environmental statement

**related to operation of
INDIAN POINT
NUCLEAR GENERATING PLANT
UNIT NO. 2**

CONSOLIDATED EDISON COMPANY OF NEW YORK, INC.

DOCKET NO. 50-247

Fig. II-2
Indian Point Site

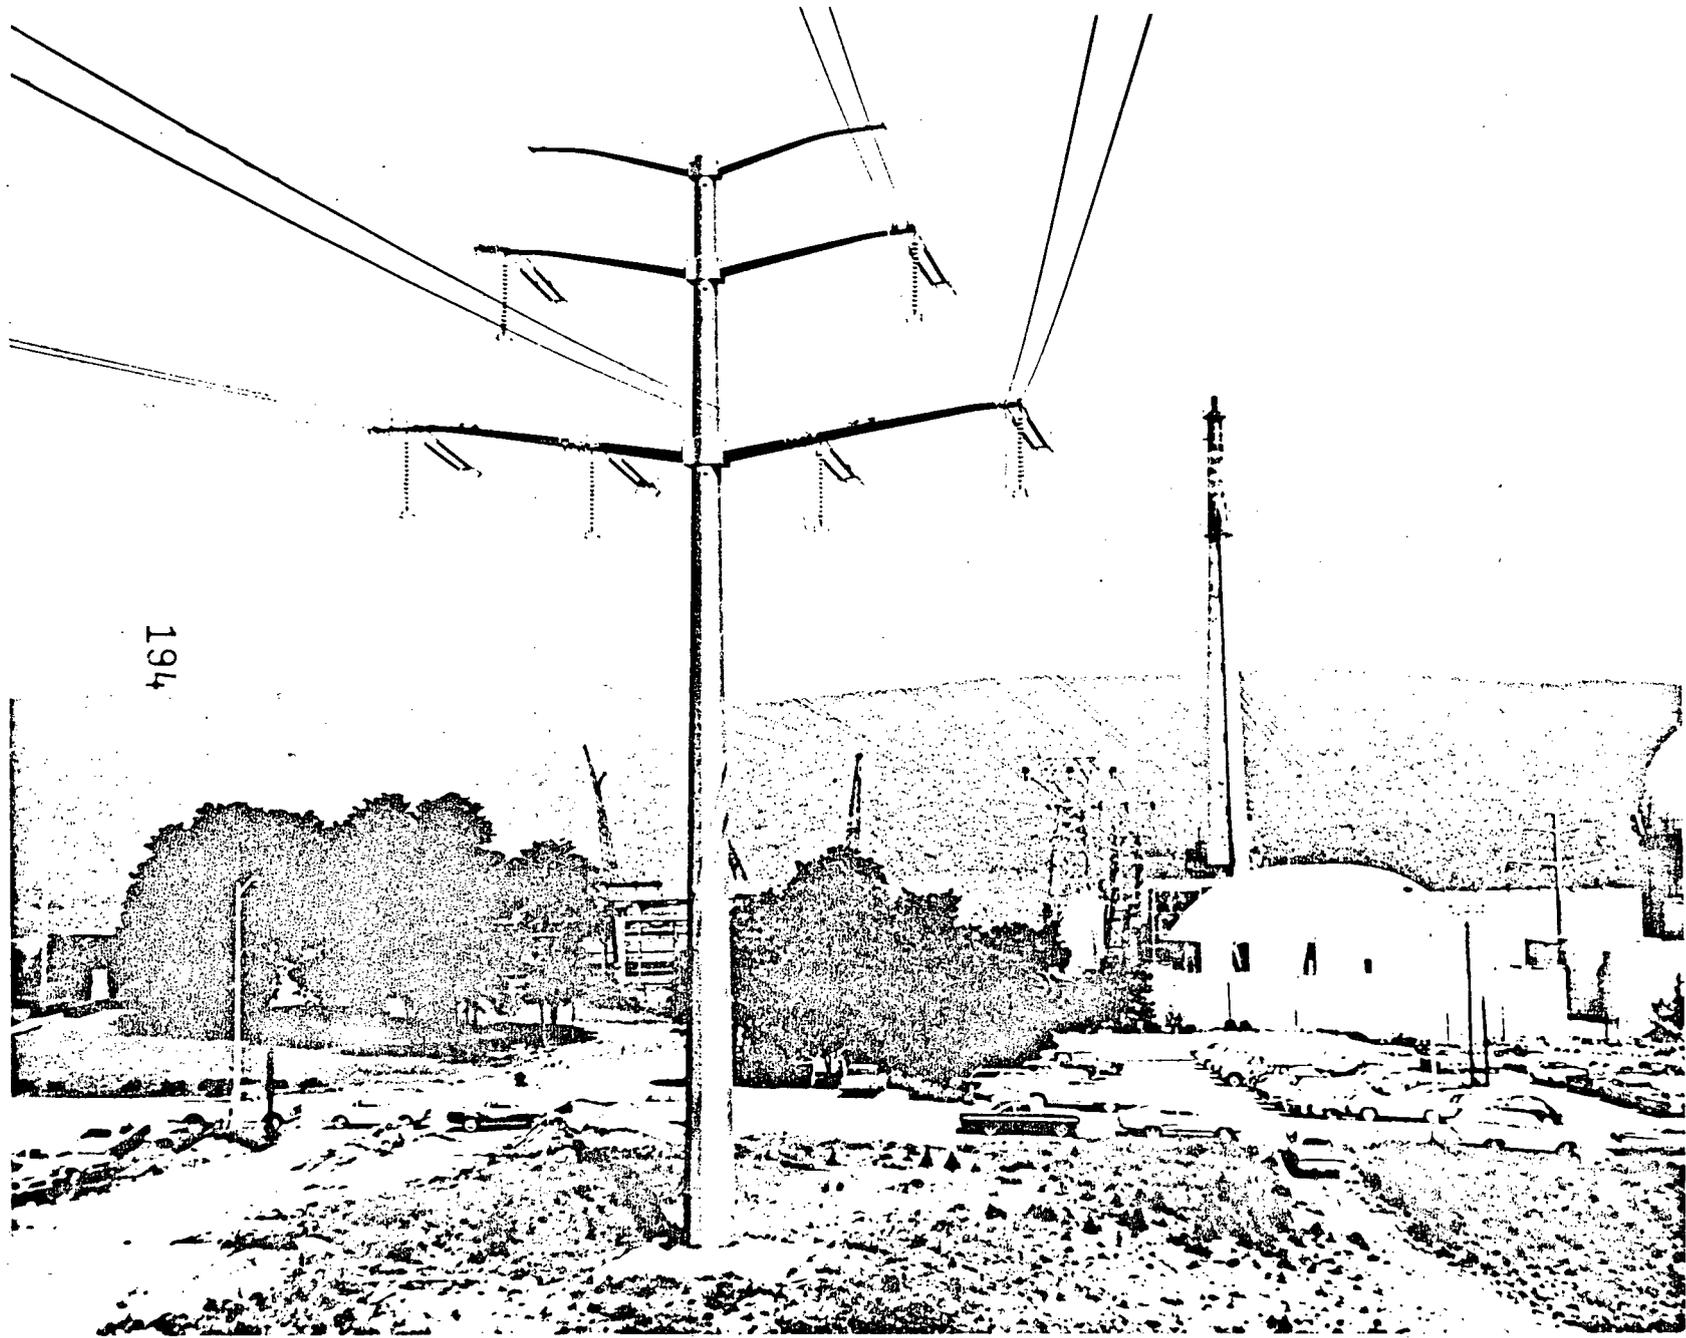
14. Page II-3, fig. II-2. :See attached figure for new location of Visitors' Center.
15. Page II-4, first para., :No Indian Point buildings can presently be seen from Peekskill, only IP-1 stack and tip of Unit 2 and Unit 3 containment can be seen.

PRIMARY COOLANT PURIFICATION
IN CHEMICAL AND VOLUME CONTROL
SYSTEM - INDIAN POINT UNIT NO. 2

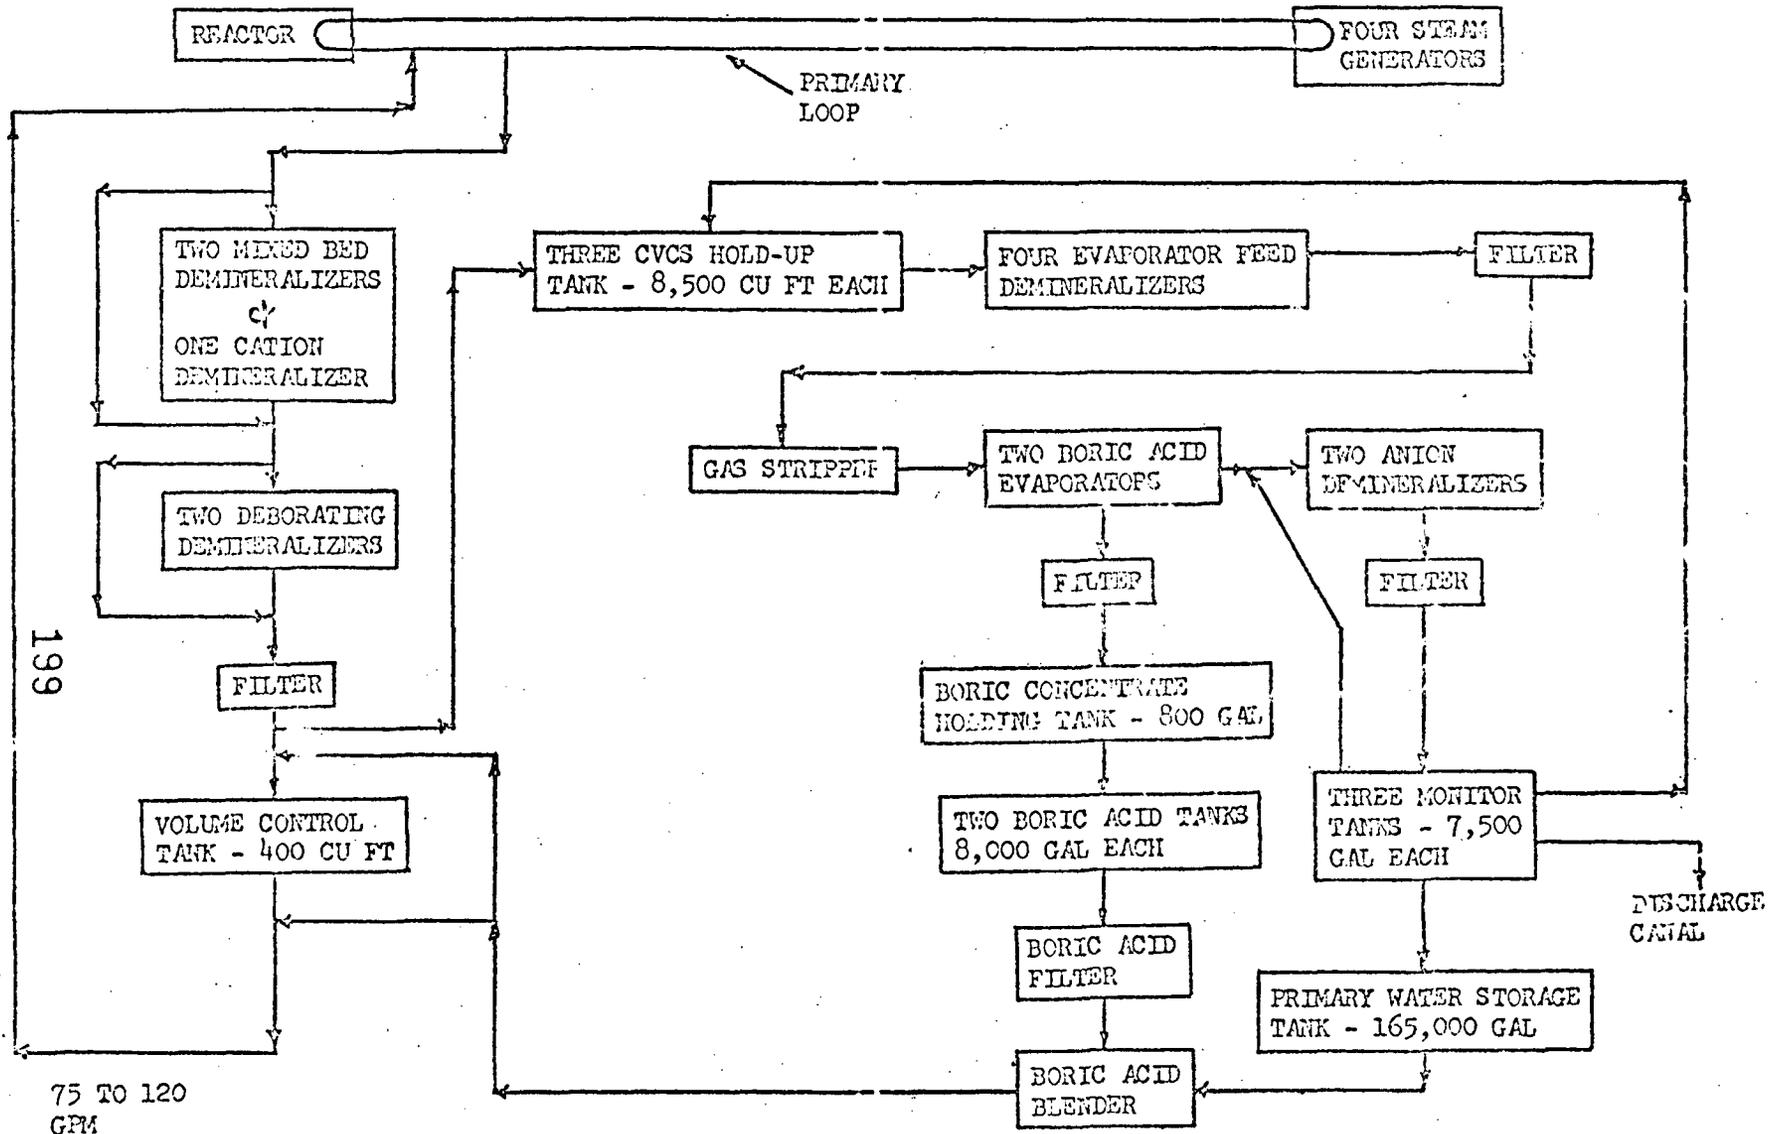
74. Page III-41, Fig. III-13. :See attached Figure (Figure 2) for more accurate description.
75. Page III-42, First para., line 2. :Two demineralizers are provided. Normally neither is used until toward the end-of-core life, then one or both may be used.
